Public Works Department – Engineering Division

ADDENDUM NO. 3

PROJECT 5067 WTP FILTER IMPROVEMENTS AND HYPOCHLORITE CONVERSION

DETAIL 5
VAR
NOT TO SCALE

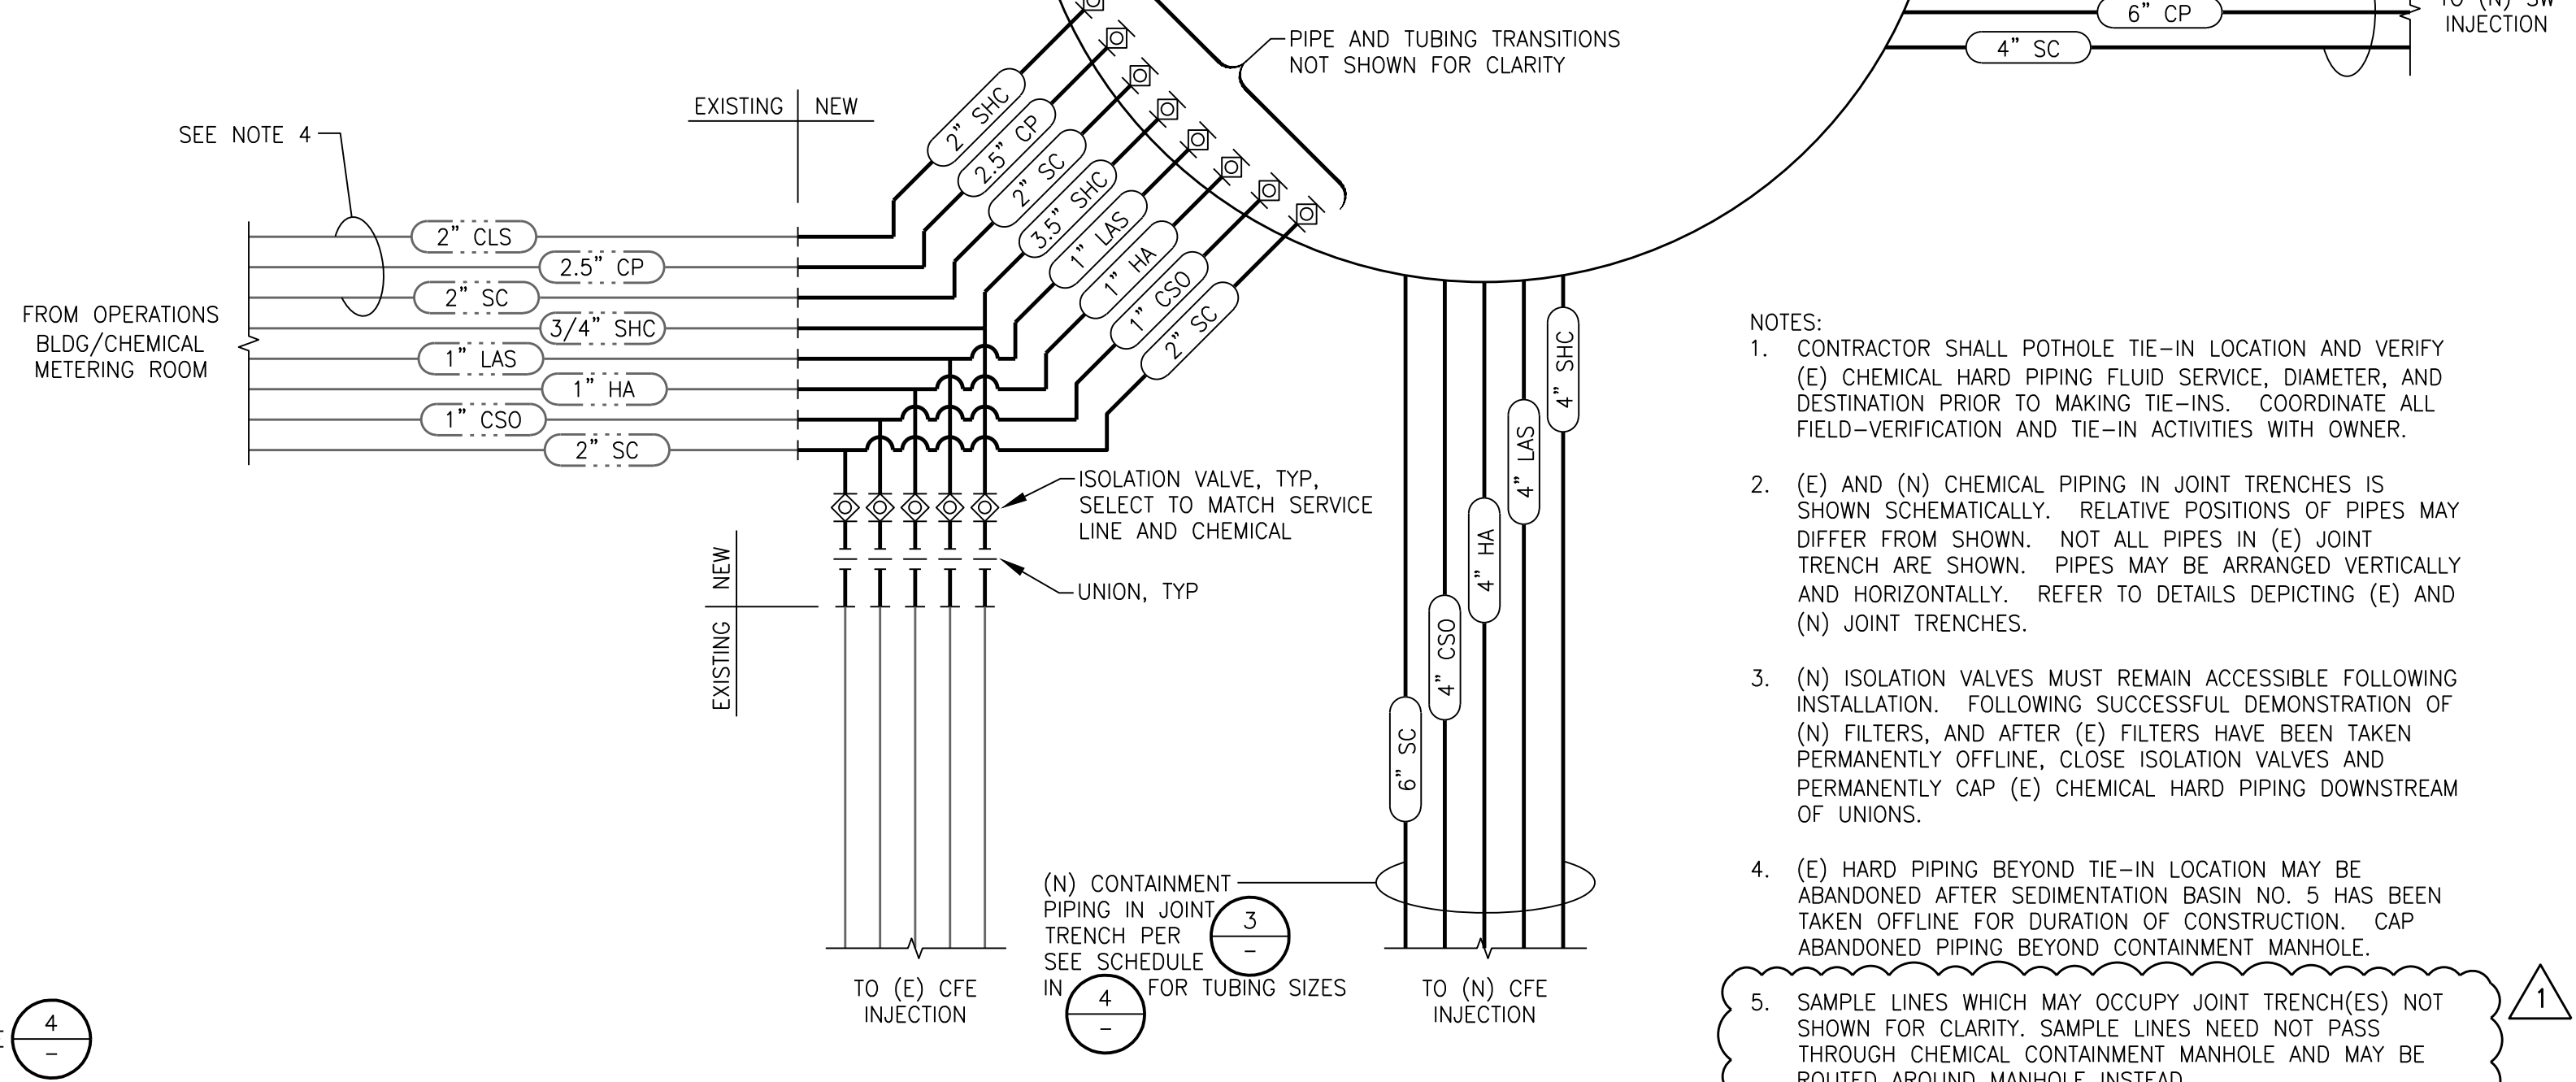
14. Replace Drawing GC004 with the attached revised Drawing GC004.
15. On Drawing C105, change the far-right callout "#5" connection to "#3" for the 30" PS2 Discharge.

30. There is a call out on the (n) Joint Trench north of the chemical manhole for a 6" SHC on C102 and does not match the sizing on the Chemical Containment Manhole Table Detail 4 on sheet GC004. Please confirm that containment pipe is meant to be 4".

36. Drawing C102 shows a new joint trench with six (6) dual contained HDPE chem lines & three (3) PVC sample lines running from the operations building to CMH#1. Detail 6 on drawing GC004 shows eight (8) existing chem lines running from the operations building to CMH#1. And P&ID I360 appears to have six (6) chem lines running through CMH#1 but not all of the systems match drawing C102. Please provide clarification/detail for the correct routing of new & existing chem lines into CMH#1, as well as the routing of the chem lines within CMH#1.

Response: New double-contained chemical piping will only be required, for new and modified chemical systems, downstream of the tie-in with existing piping upstream of new Chemical Containment Manhole No. 1. New sample lines may occupy joint trench with chemical lines where practical but need not go through chemical containment manholes (and may wrap around them as needed). See this addendum, Item A.13. and A.14 for revised drawings C102 and GC004. Drawing I360 will be updated as part of Addendum 4.

Response: New double-contained chemical piping will only be required for new and modified chemical systems and downstream of the tie-in with the existing piping upstream of new Chemical Containment Manhole No. 1. New sample lines may occupy joint trenches with chemical lines where practical but need not go through chemical containment manholes (and may wrap around them as needed). See this addendum, Item A.13. and A.14 for revised drawings C102 and GC004. Drawing I360 will be updated as part of Addendum 4.

Response: No, the new chemical containment manholes need not be coated, as the required material, HDPE, is resistant to corrosion. Refer to callout indicated HDPE material in Detail 4, Drawing GC004.

DWG. NO.
C102

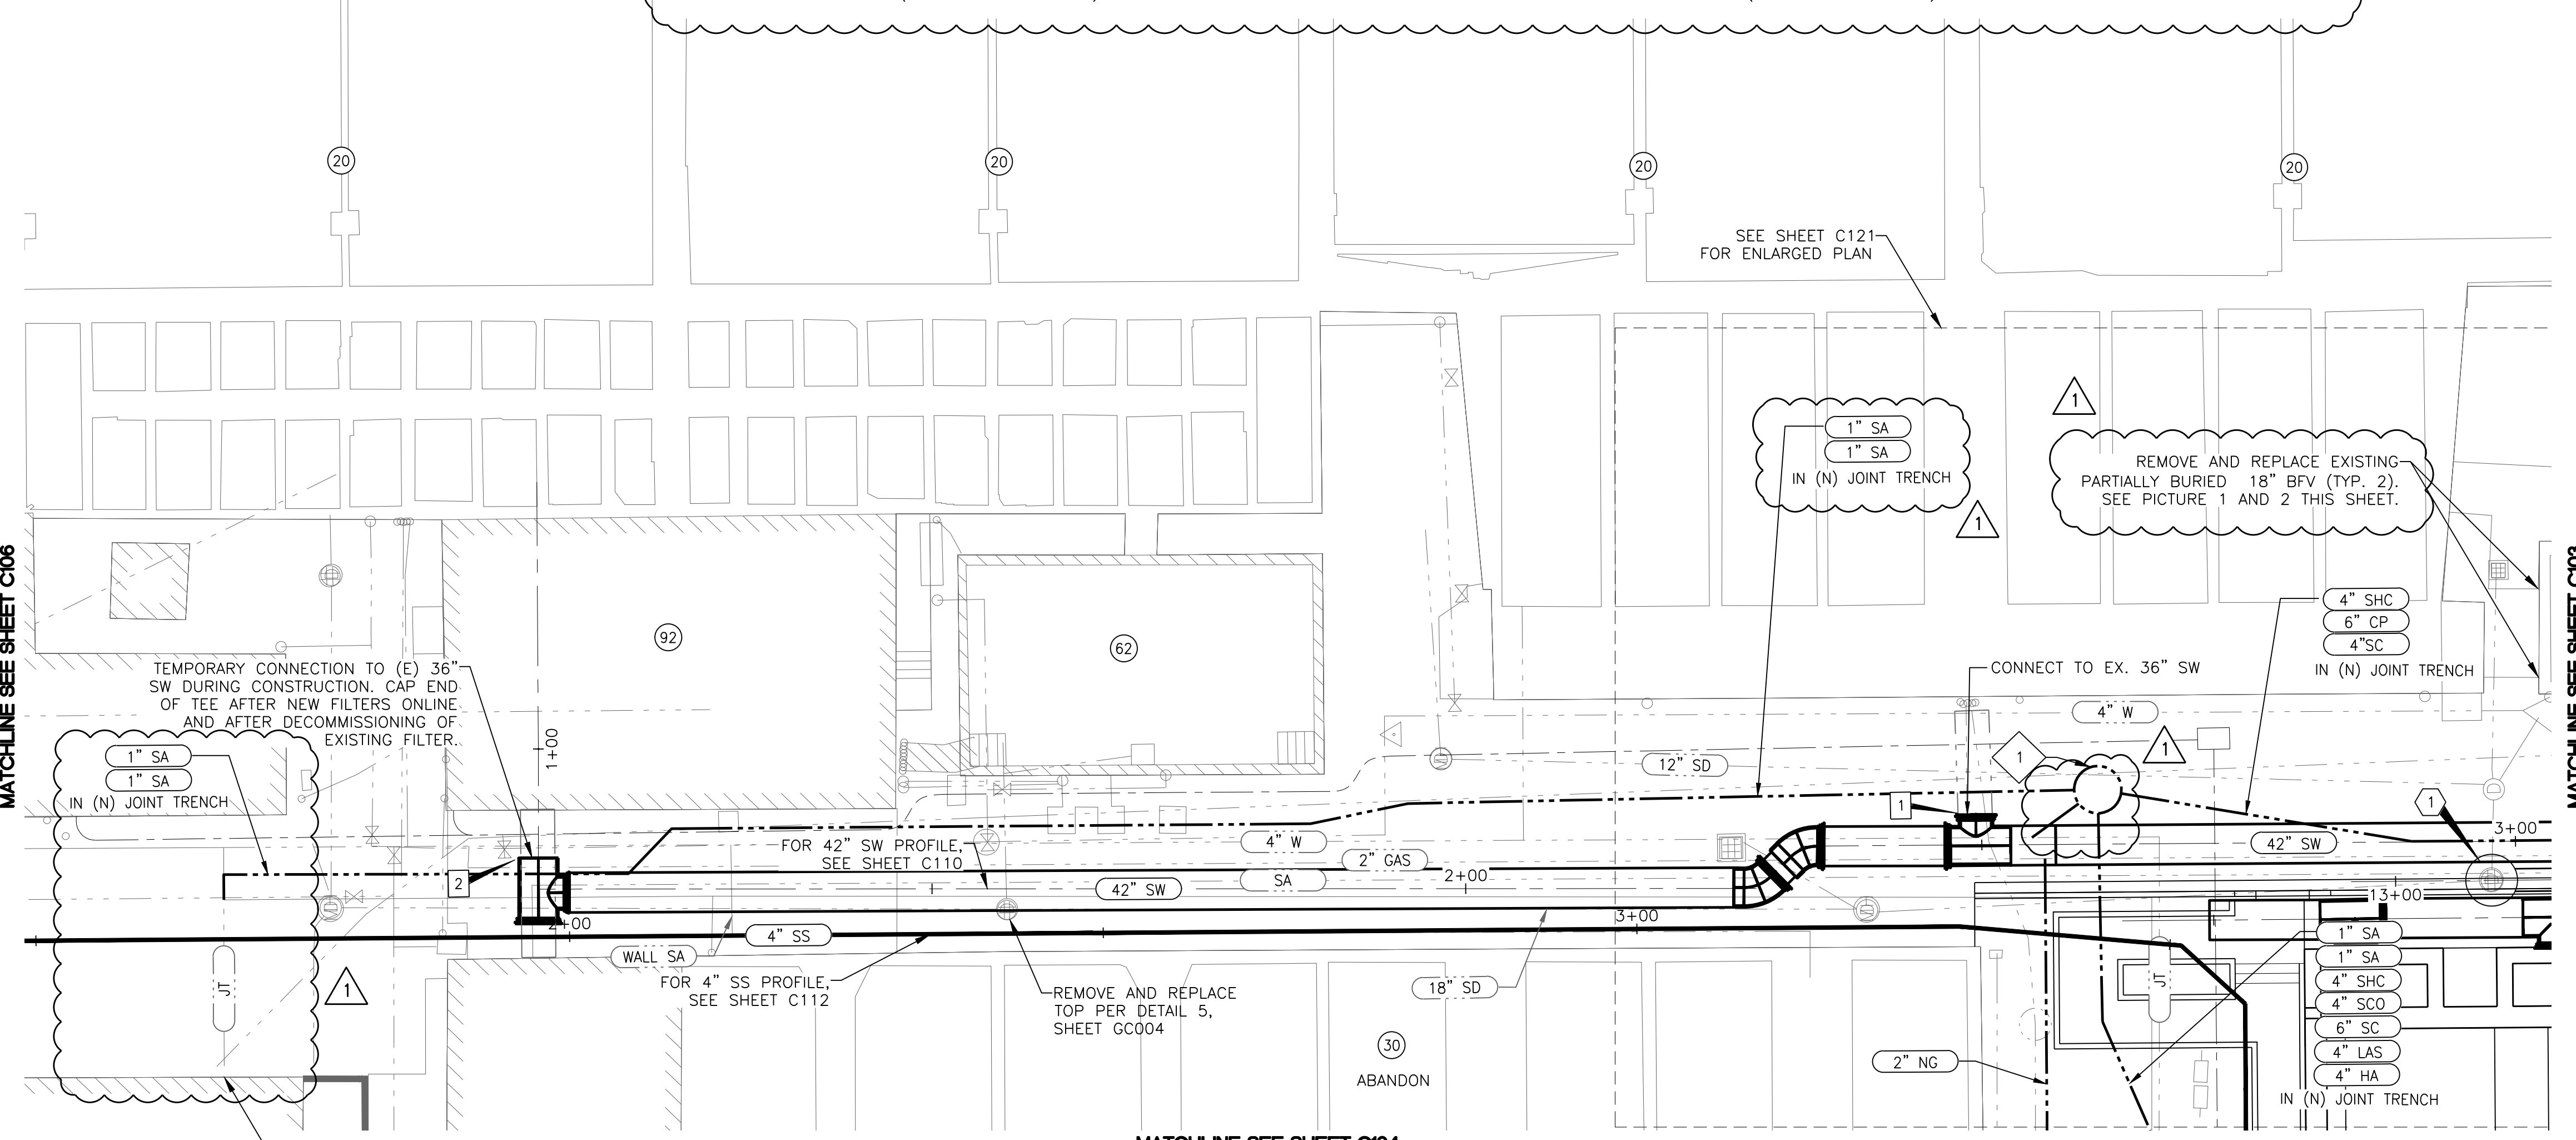
12. On Drawing C105 and CP002, change all references for new piping labeled "WL" or "W" to "1W".
13. Replace Drawing C102 with the attached revised Drawing C102.

69. Drawing C102 has a call out to “Remove and replace existing partially buried 18” BFV (typ 2)”. This call out is not repeated on the enlarged drawing C121. Please provide more information about these valves.

Response: Photos have been added to sheet C102 to provide more context about the two 18” BFV’s.
